Date	Rev.	Status or Amendment
28/08/17	A	Issue for DA Amendment

Pursuant to section 197 of the *Planning and Development Act 2007*, approval is sought to amend development approval No. 201630289 dated 13/12/2016 as described at **Attachment A.**

Project: Canberra Labor Club Belconnen Hotel
Blocks: 8+9 | Section: 48 | Division: Belconnen
Drawing Title: Ground Floor Plan
Job No.: 16_35 | Drawing No.: DA-A101 | Scale: 1 : 100@A1 | Rev.: F

Drawing Title: Level 3 Carpark South Floor Plan

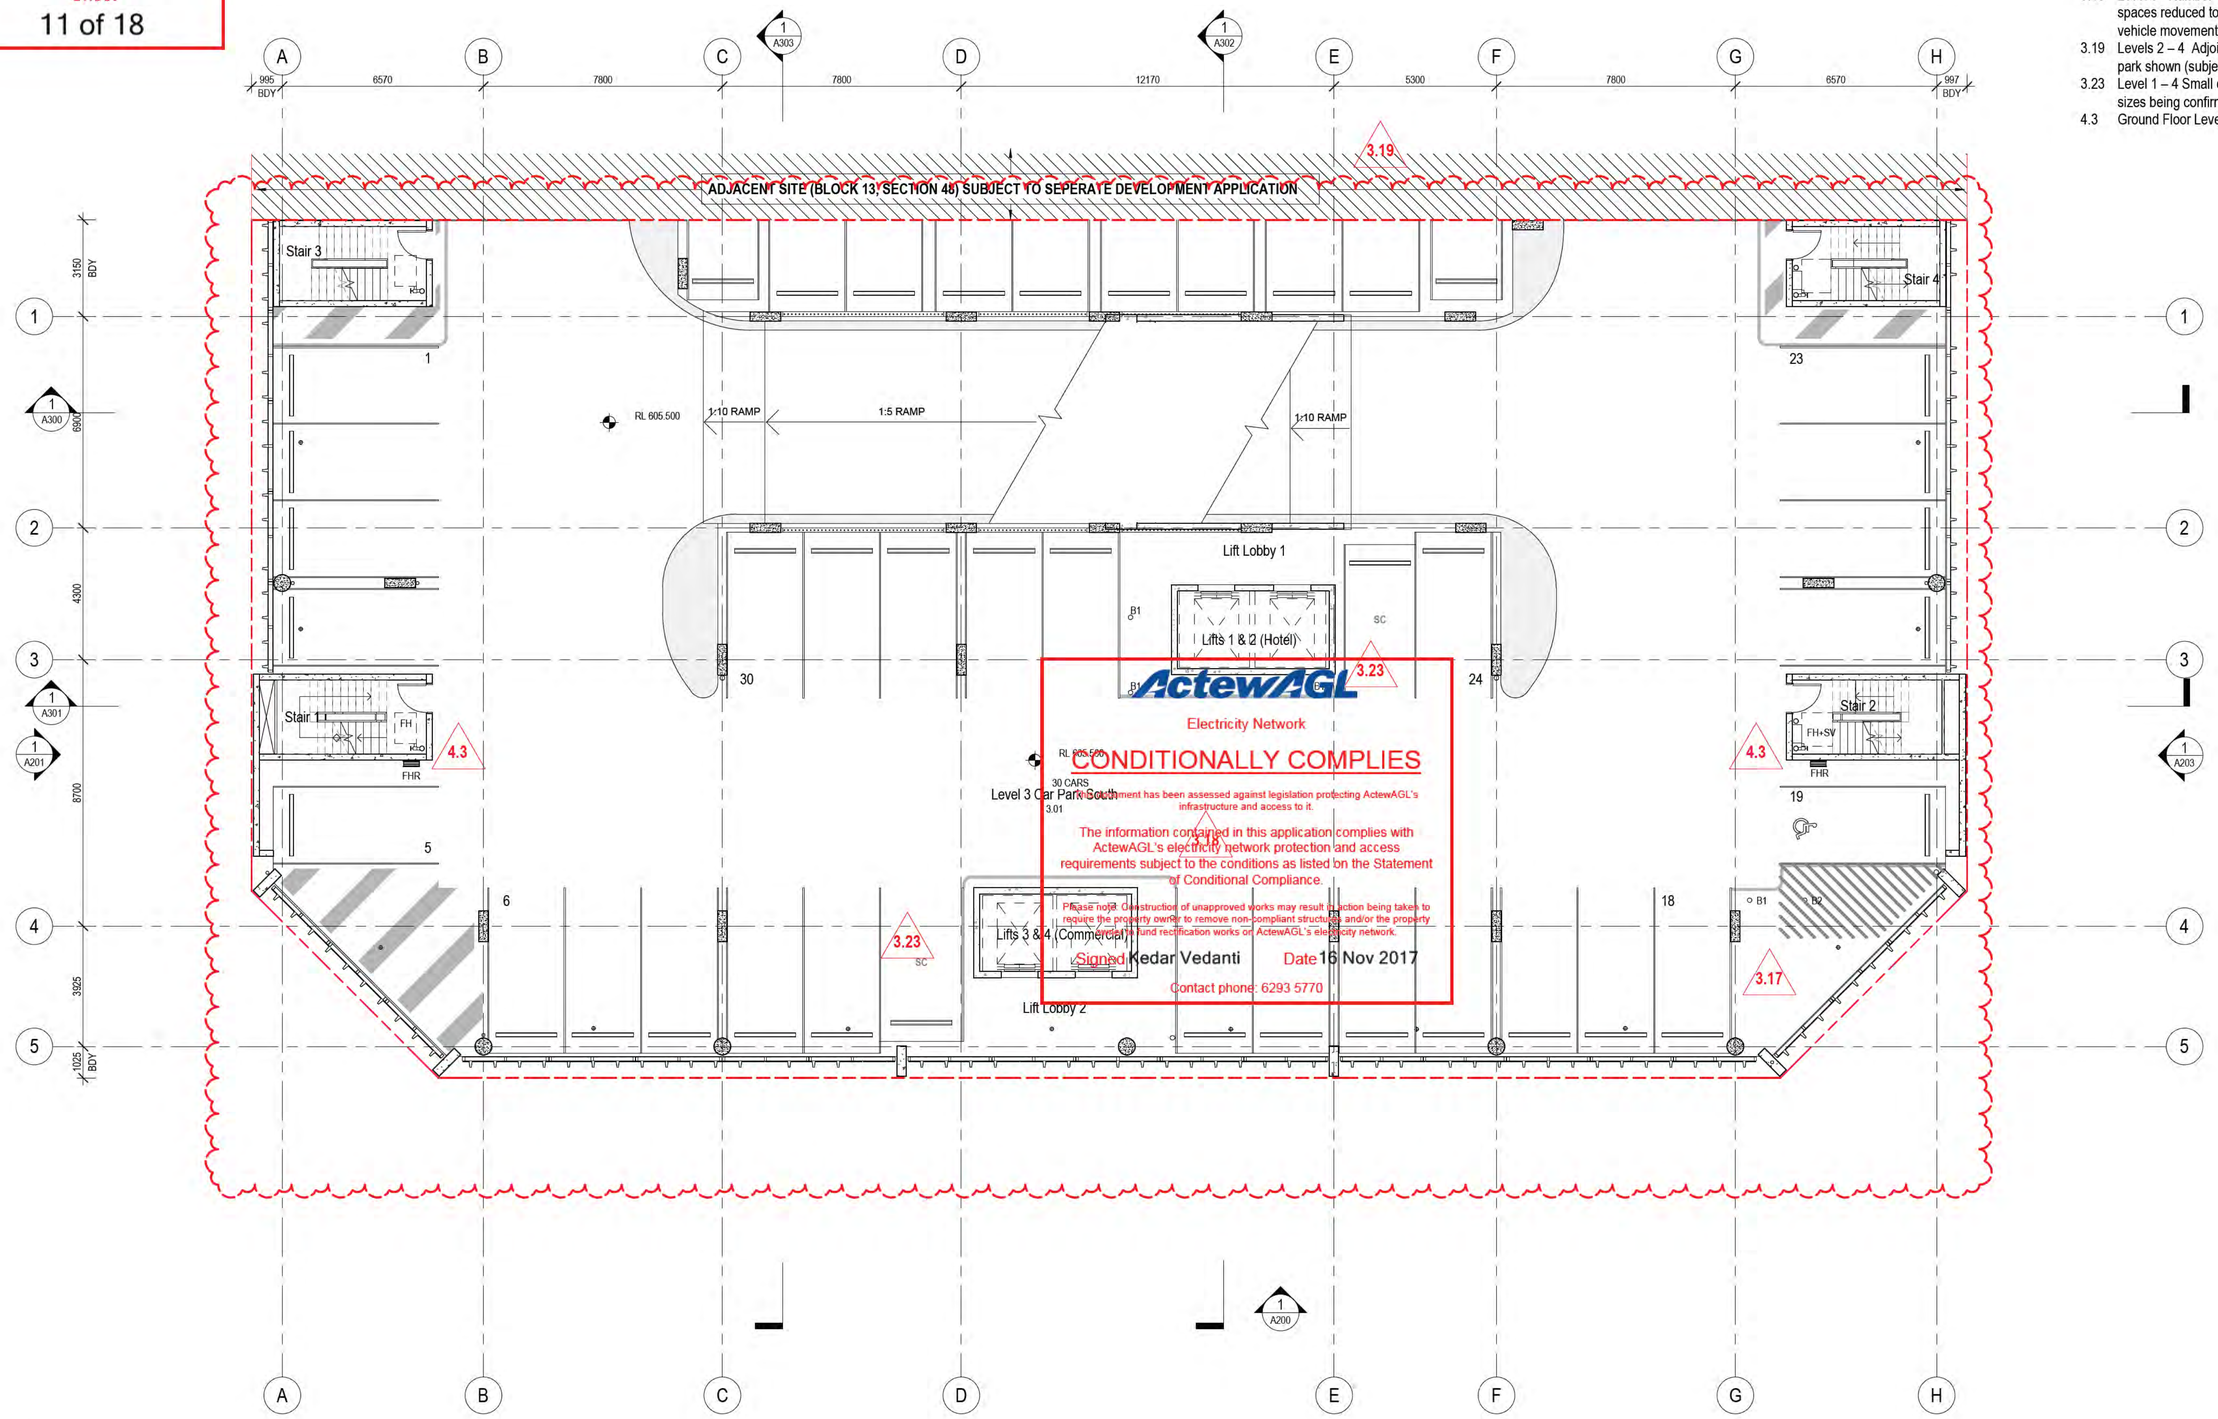
3.17 Levels 1 – 4 Bicycle Parking relocated to the Basement Level.
3.18 Level 3 - Number of spaces reduced to 30. Number of disabled spaces reduced to 1. Carpark numbers reduced to improve vehicle movement and turning manoeuvres.
3.19 Levels 2 – 4 Adjoining Canberra Labor Club podium level car park shown (subject to separate DA submission).
3.23 Level 1 – 4 Small car spaces (9 total) introduced due to lift shaft sizes being confirmed and adjustment to stair 2 on Level 4.
4.3 Ground Floor Level and Levels 1 - 3 – Stair Nos. 1 - 2 added.

Drawing Title: Level 4 Carpark South Floor Plan

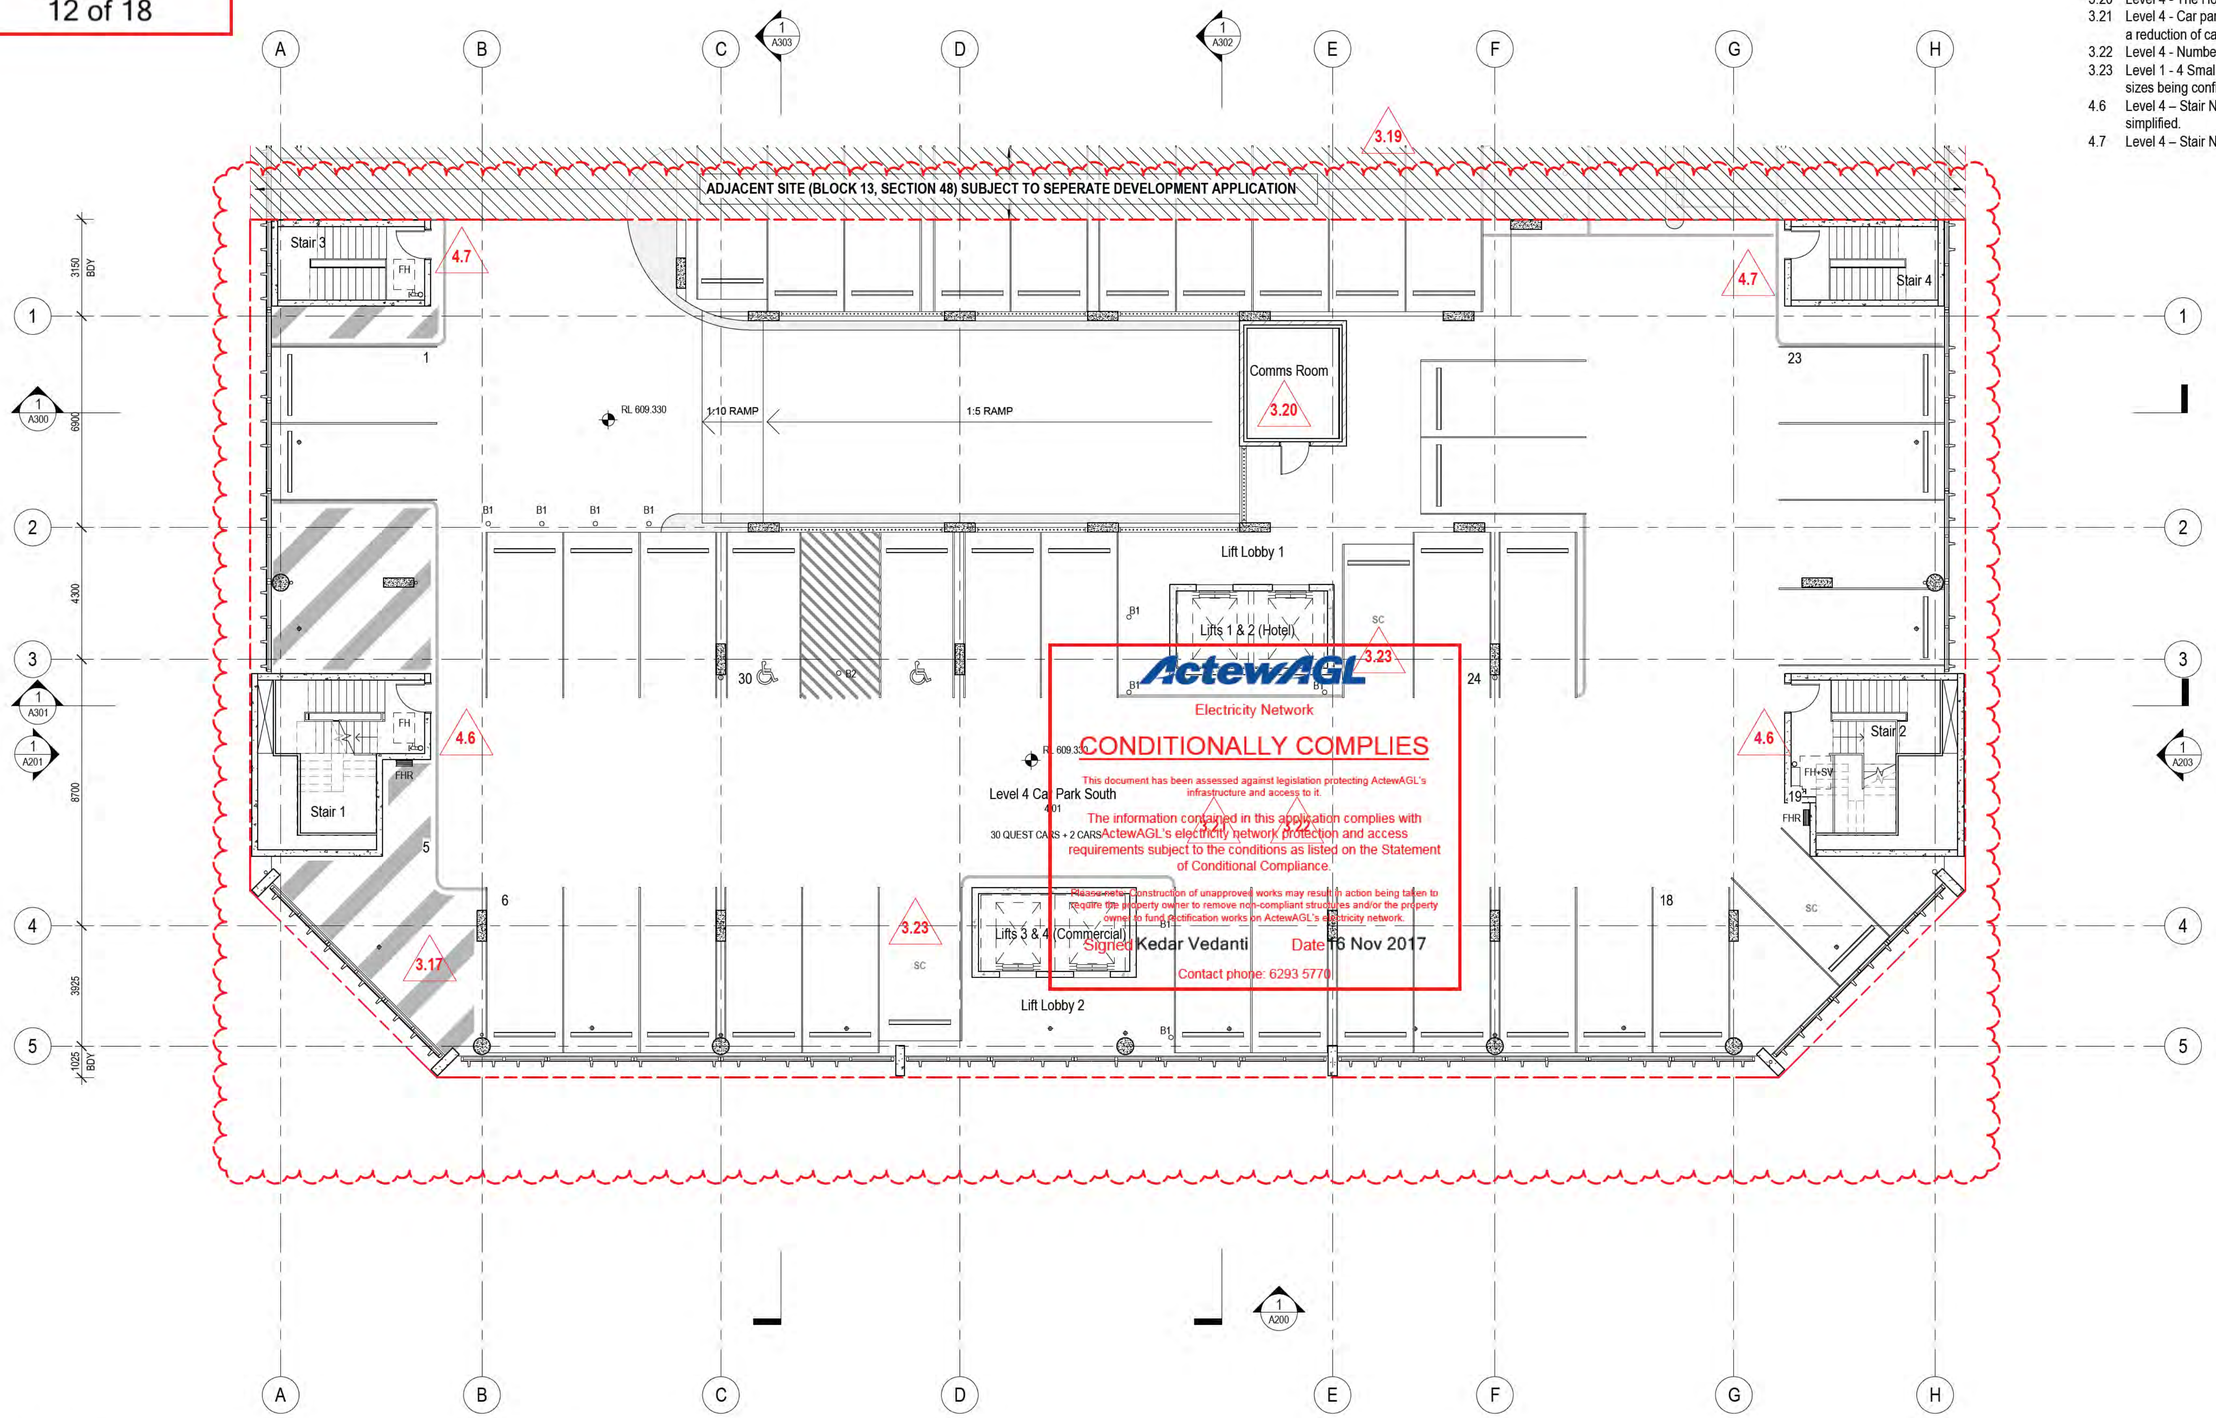
3.19 Levels 2 – 4 - Adjoining Canberra Labor Club podium level car park shown (subject to separate DA submission).
3.20 Level 4 - The Hotel Communications Room has been relocated.
3.21 Level 4 - Car park layout and movement amended, resulting in a reduction of car parking spaces.
3.22 Level 4 - Number of spaces increased to 32.
3.23 Level 1 - 4 Small car spaces (9 total) introduced due to lift shaft sizes being confirmed and adjustment to stair 2 on Level 4.
4.6 Level 4 – Stair Nos. 1 - 2 re-configured and vertical connectivity simplified.
4.7 Level 4 – Stair Nos. 3 – 4 added.

Drawing Title: Level 5 Hotel Floor Plan

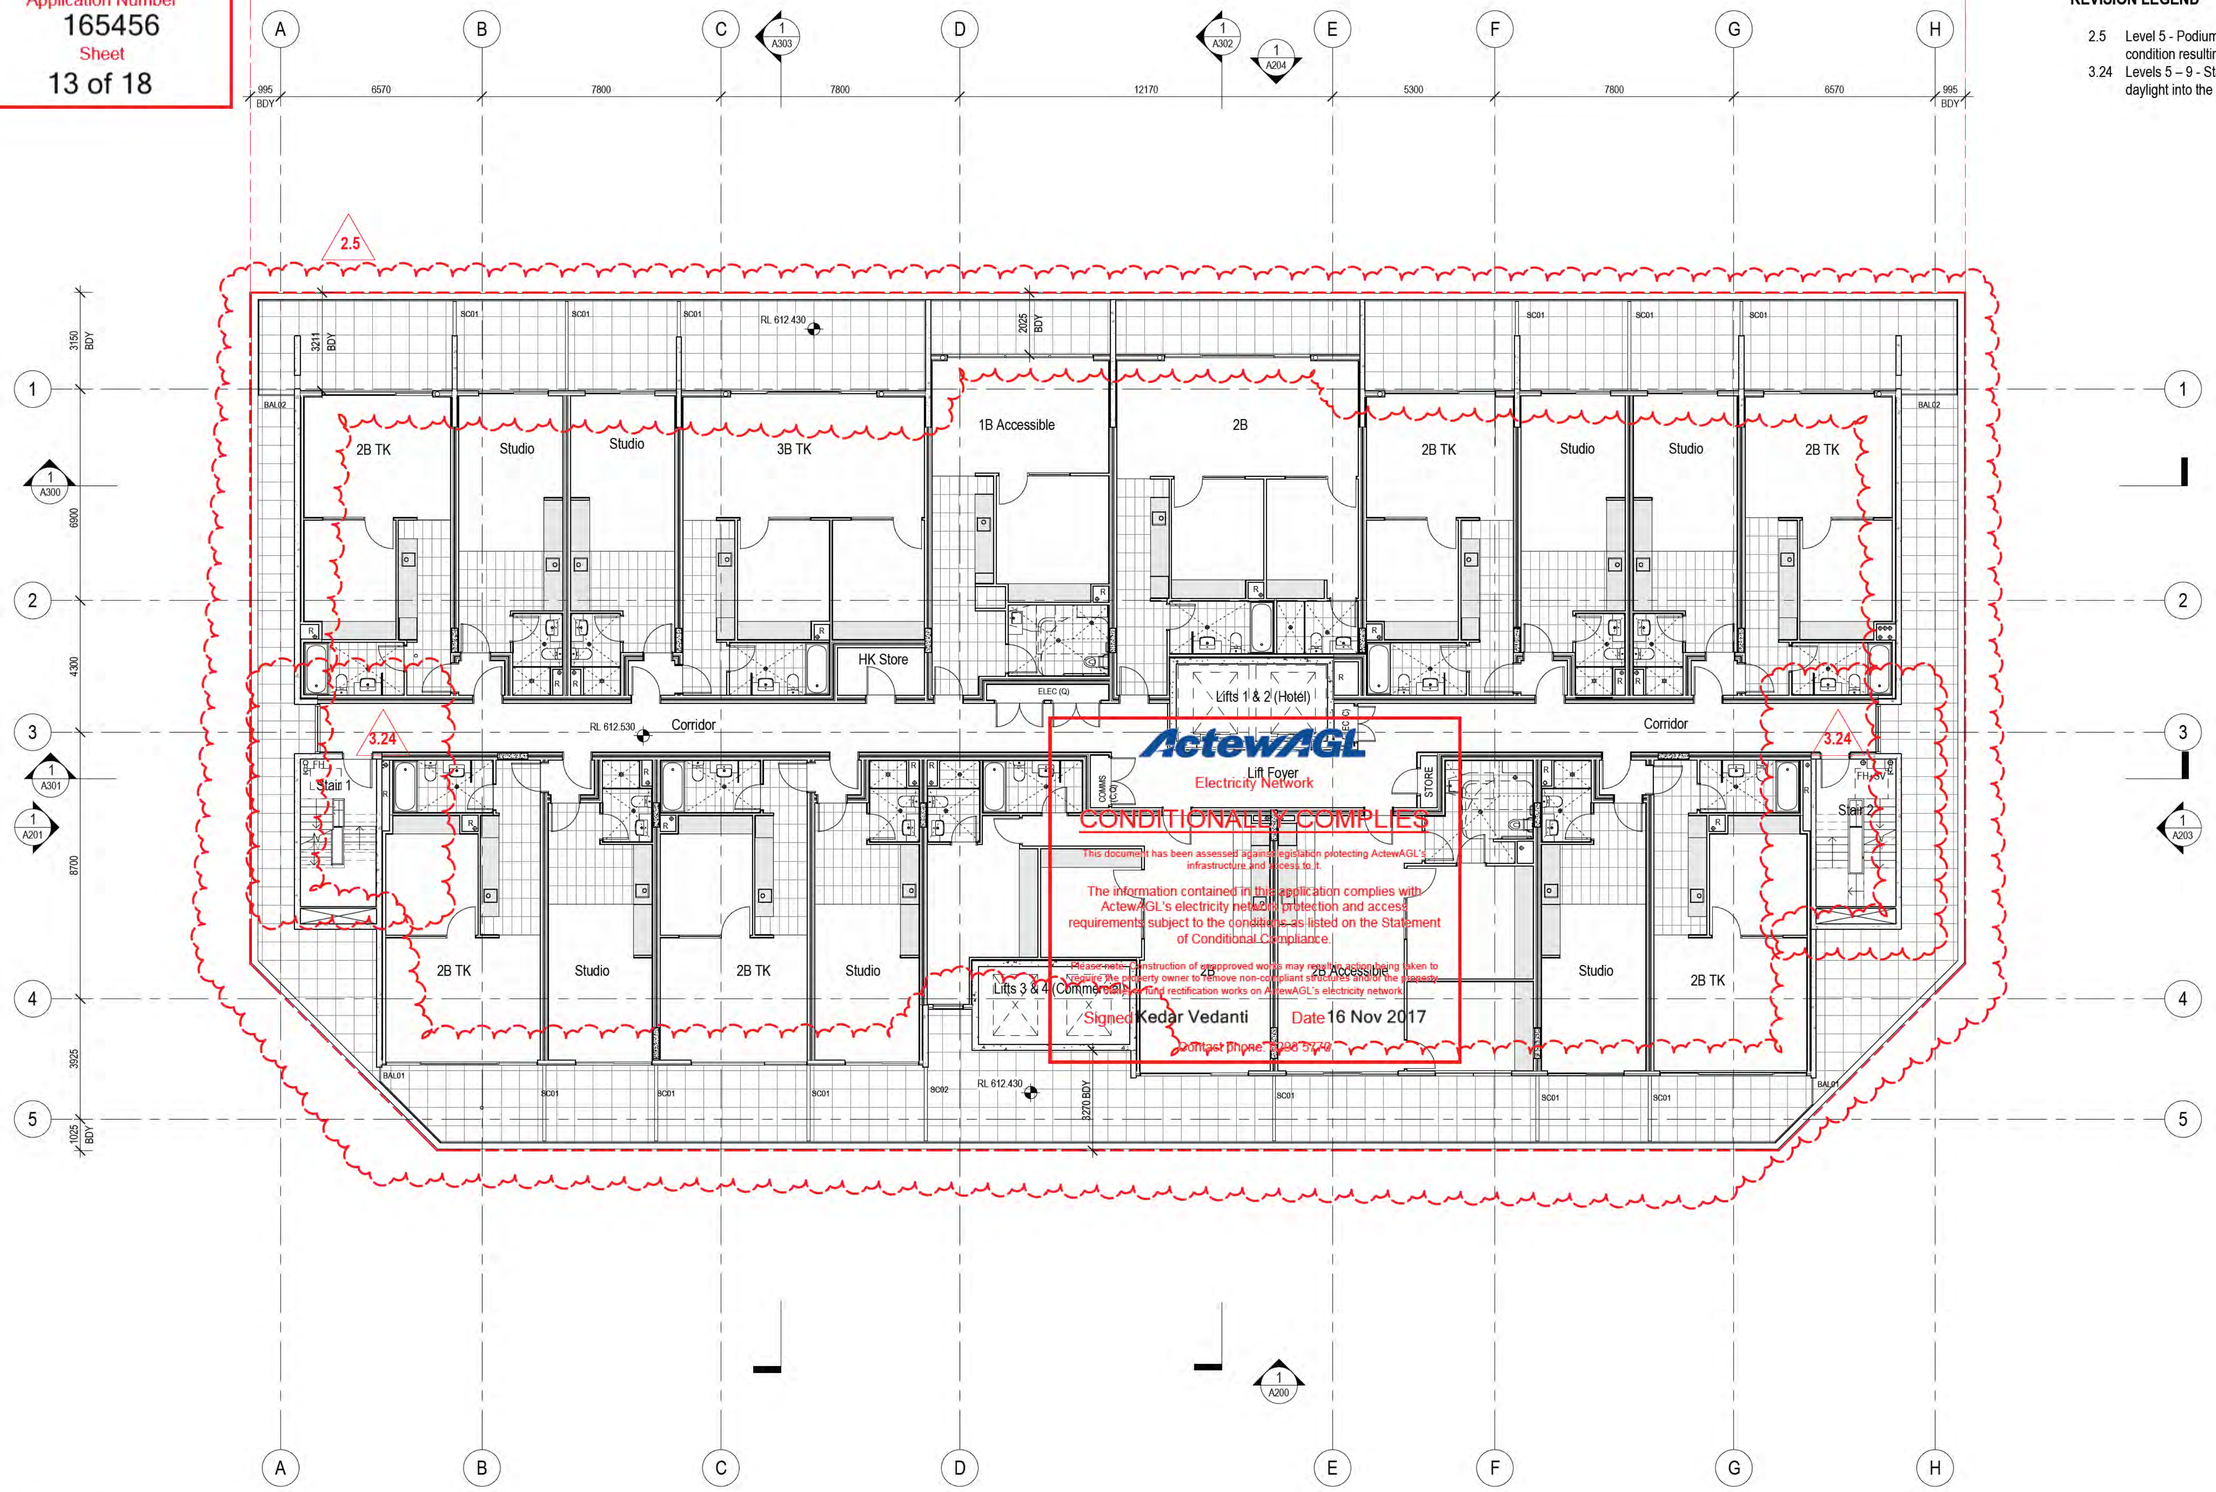
2.5 Level 5 - Podium introduced with courtyard spaces. Perimeter condition resulting in a concrete upstand with metal balustrade.
3.24 Levels 5 – 9 - Stair Nos. 1 - 2 moved to the south to allow daylight into the internal access corridor space.
